# **Assesment of AV Lite Feature for ATA-7**

**IDEMA – JAPAN  
Consumer HDD Committee**

## Timer Setting & Management CCTL (Streaming Feature Set)

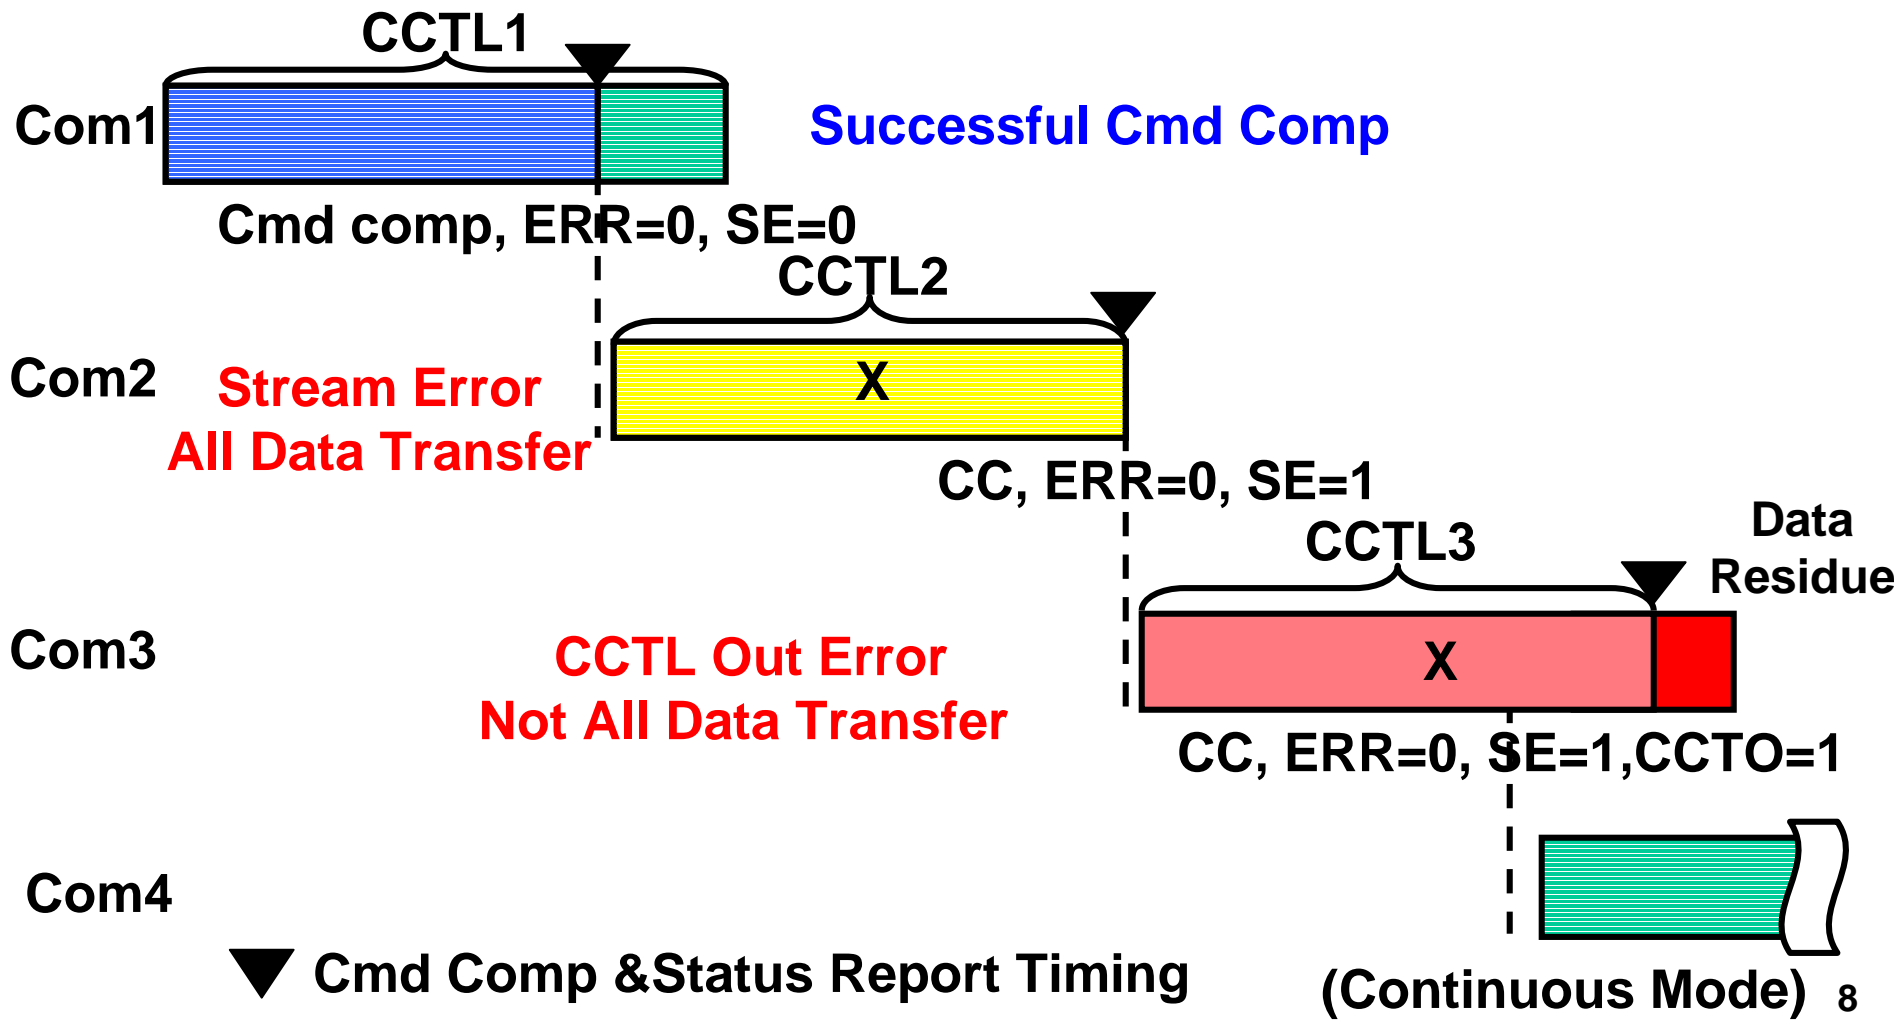
Relation between CMD, Time Period, and R/W Data Size are Clear

## Timer Setting & Management CCTL (AV Lite)

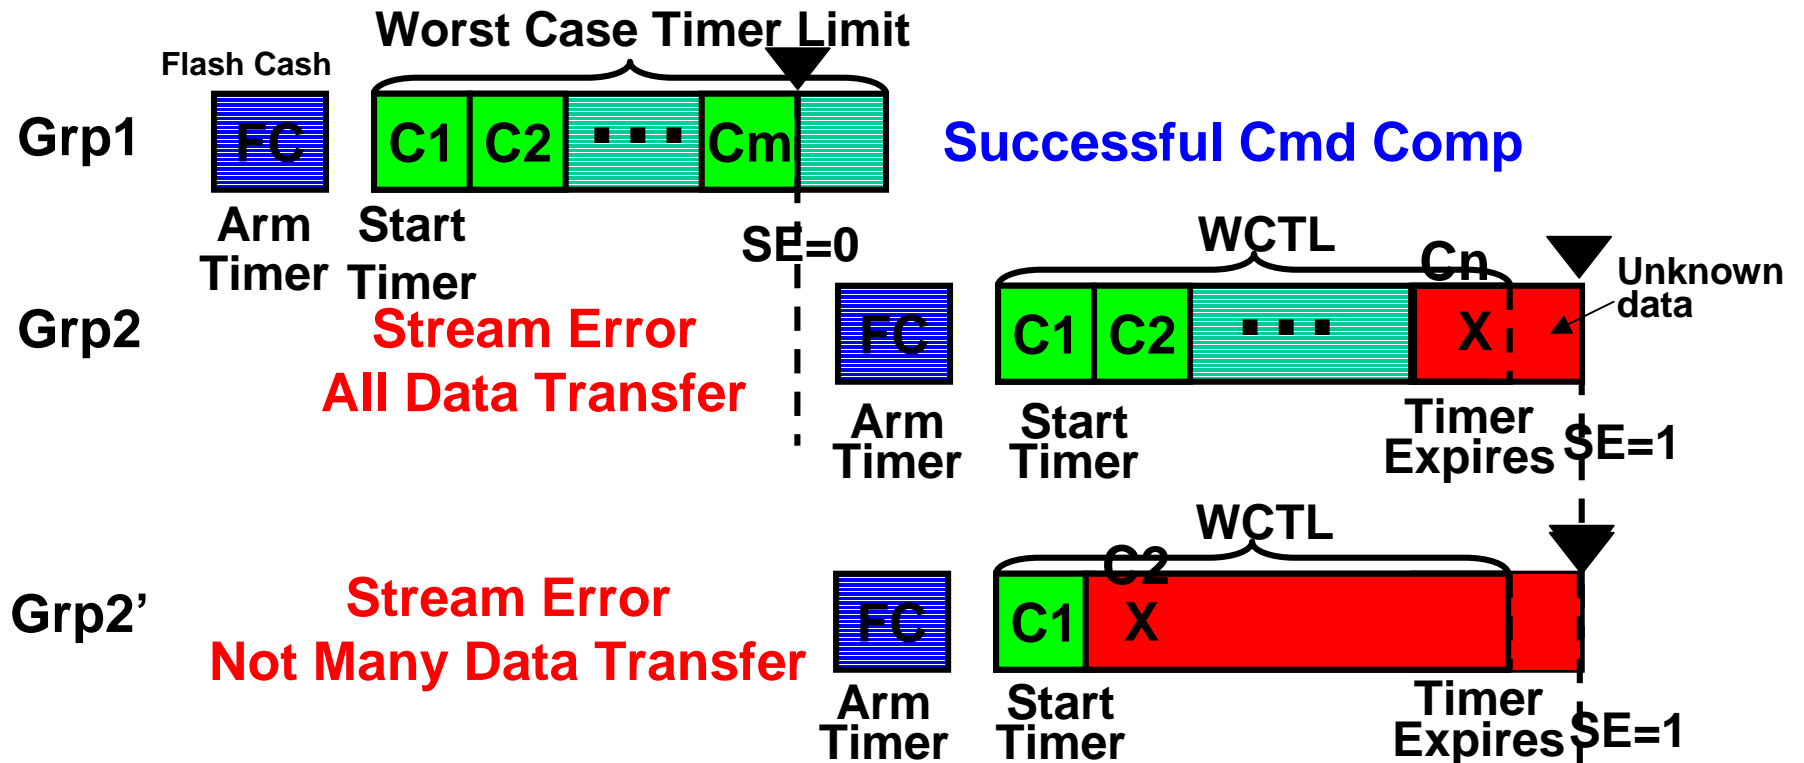
Relation between CMD, Time Period, and R/W Data Size are not Clear

- Command completion within WCTL is not guaranteed.
- Device has no knowledge of the total number of commands, total sector count to be issued in a group of commands.

## Timer Setting & Management CCTL

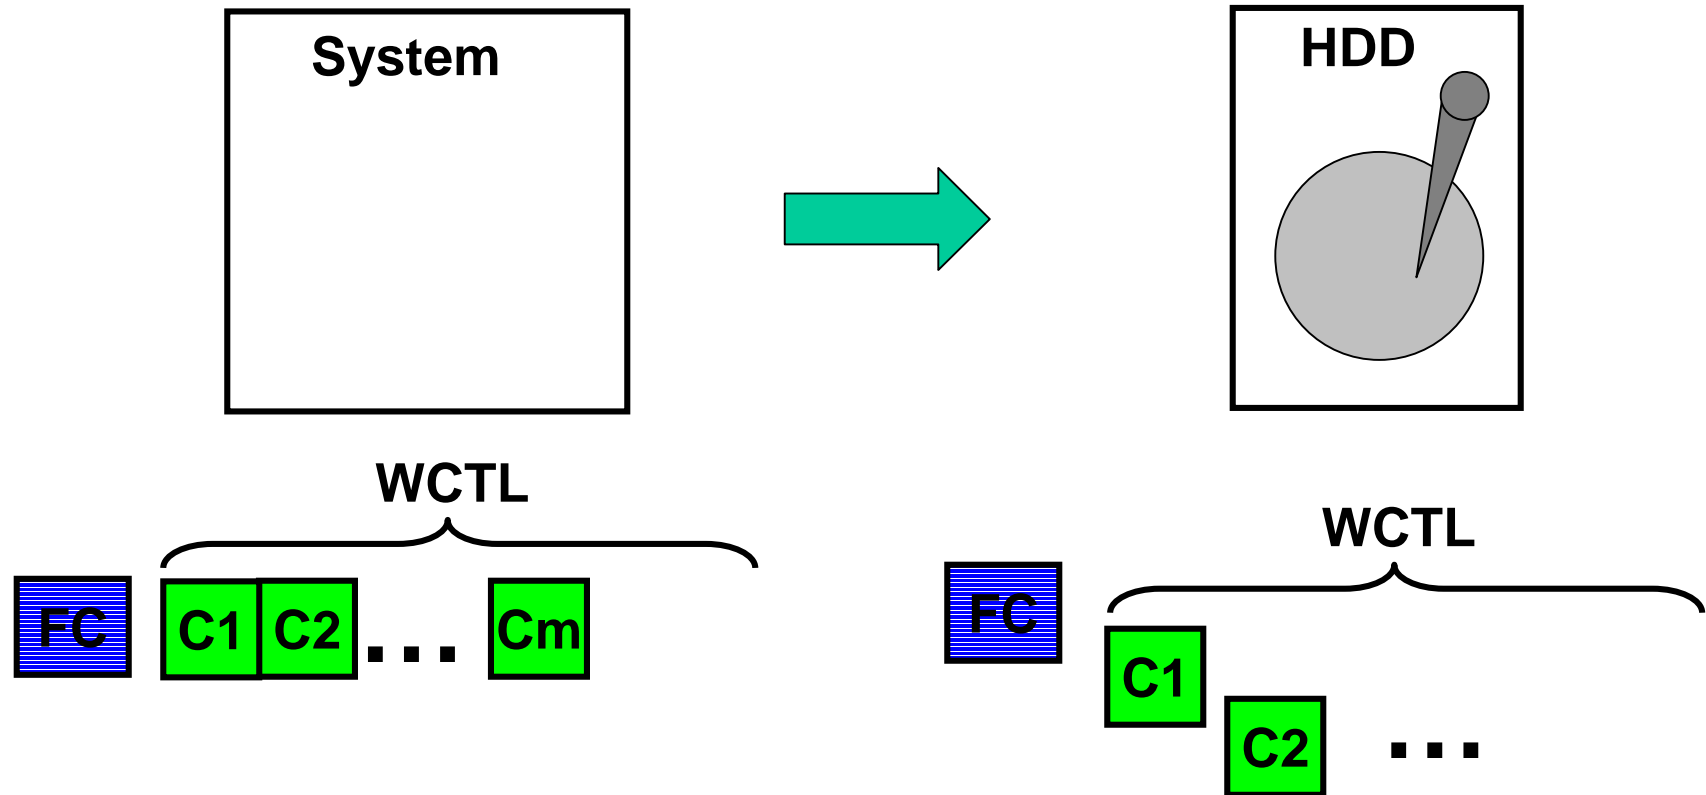
Relation between CMD, Time Period, and R/W Data Size are not Clear

System only know  
total number of commands  
total sector count

Device only know  
each CMD's parameter  
**can not know Desired behavior**

# Why Independent CCTLs is needed ?

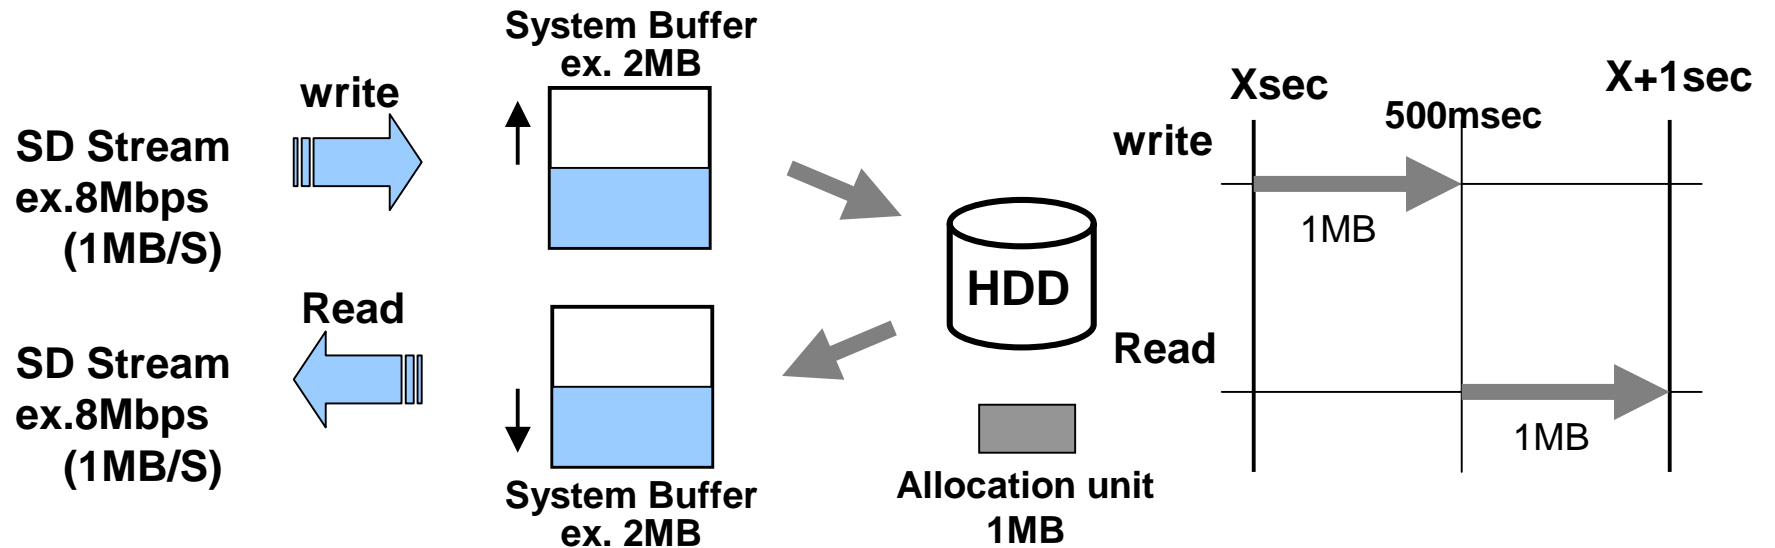
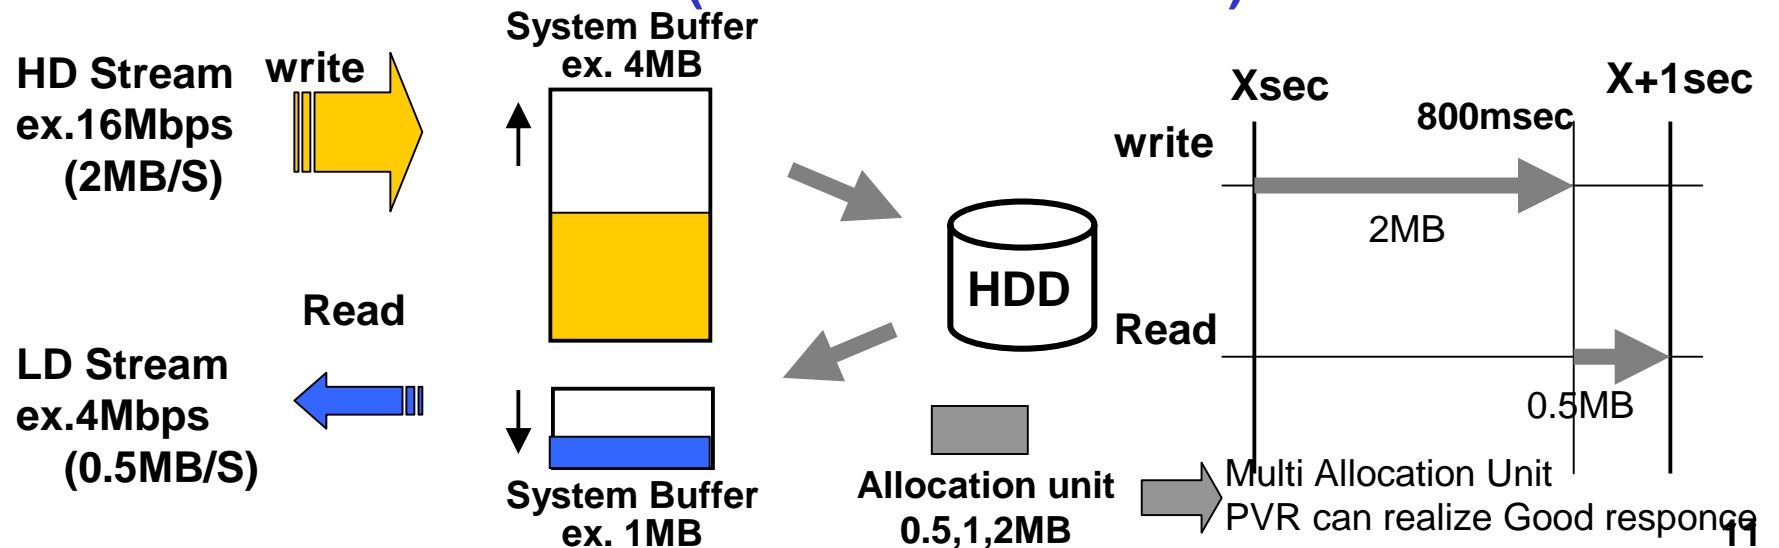
## 1. Basic Case: Same CCTL

## 2. Actual Case: Different CCTL (stream ID must need)

# Why HSE bit is needed ?

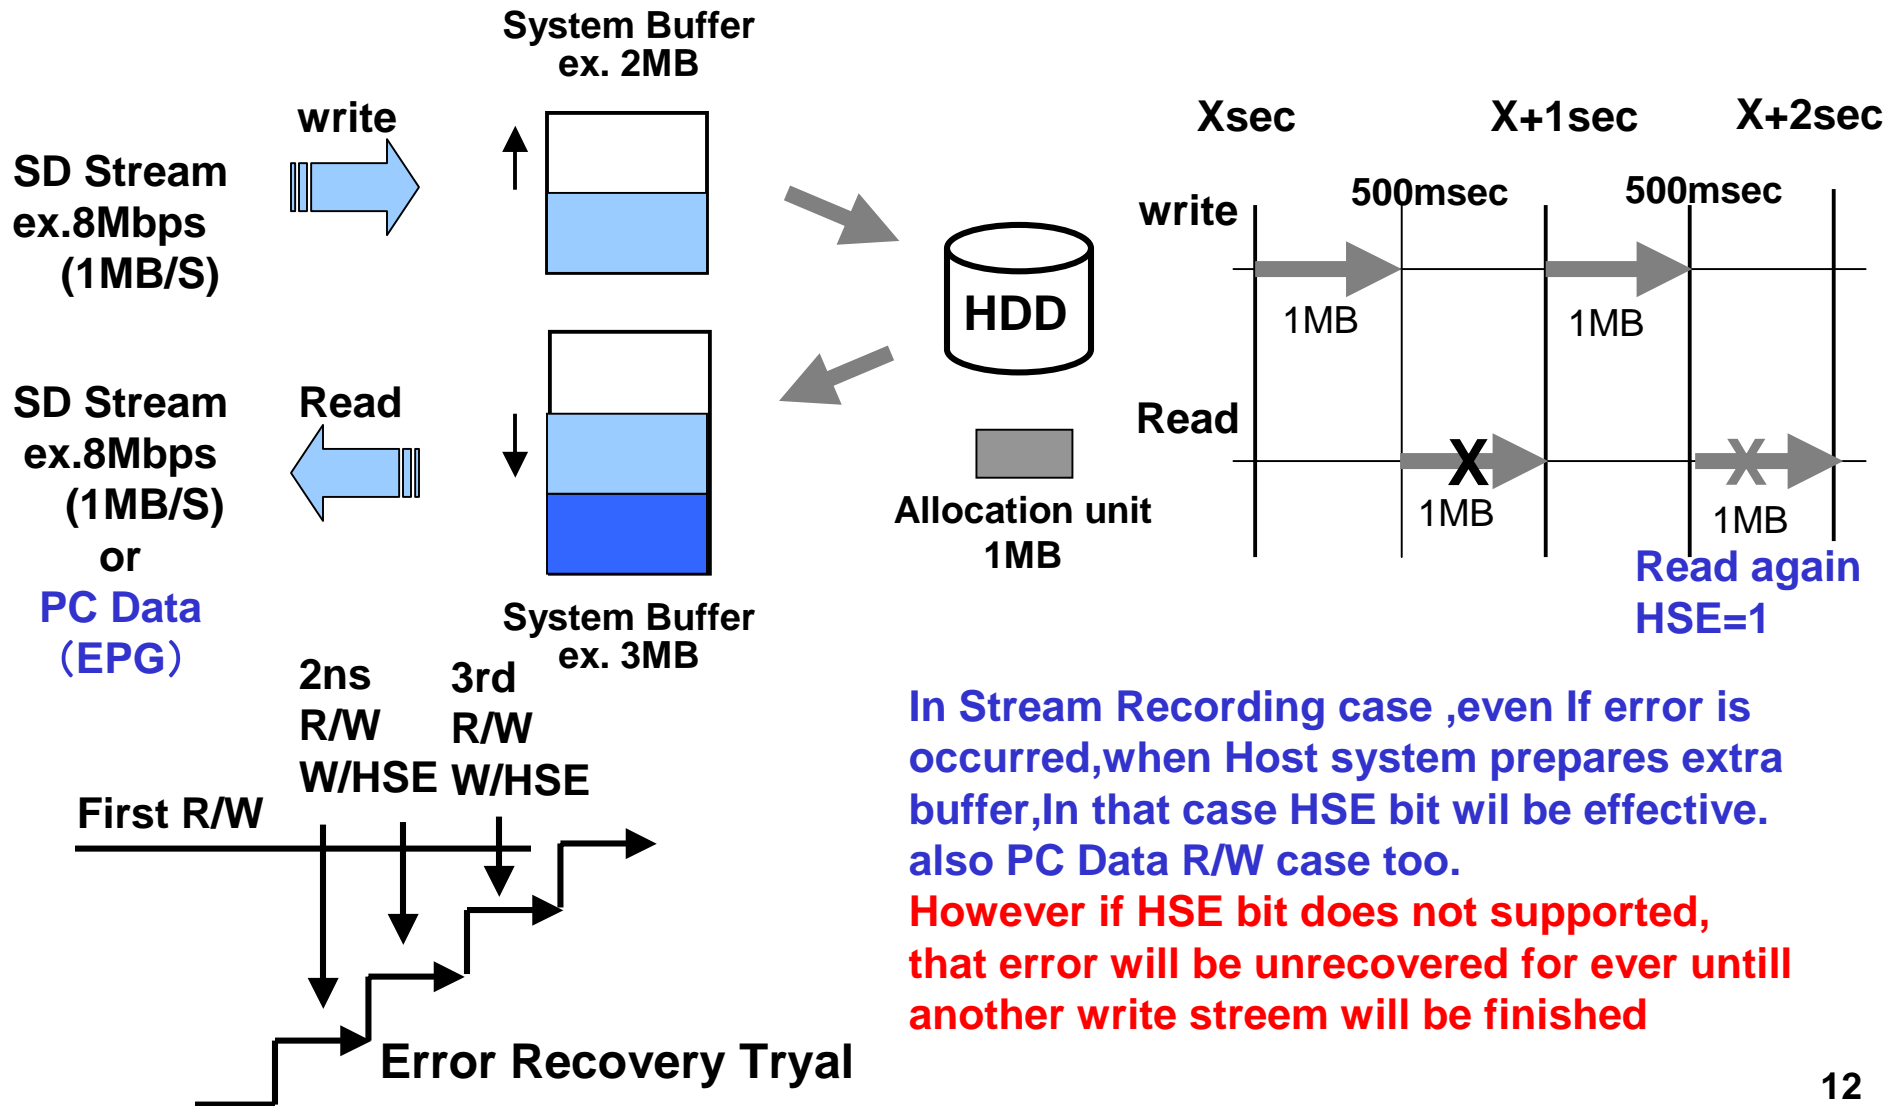
## 3.Actual Case-2:CCTL+Handle Stream error
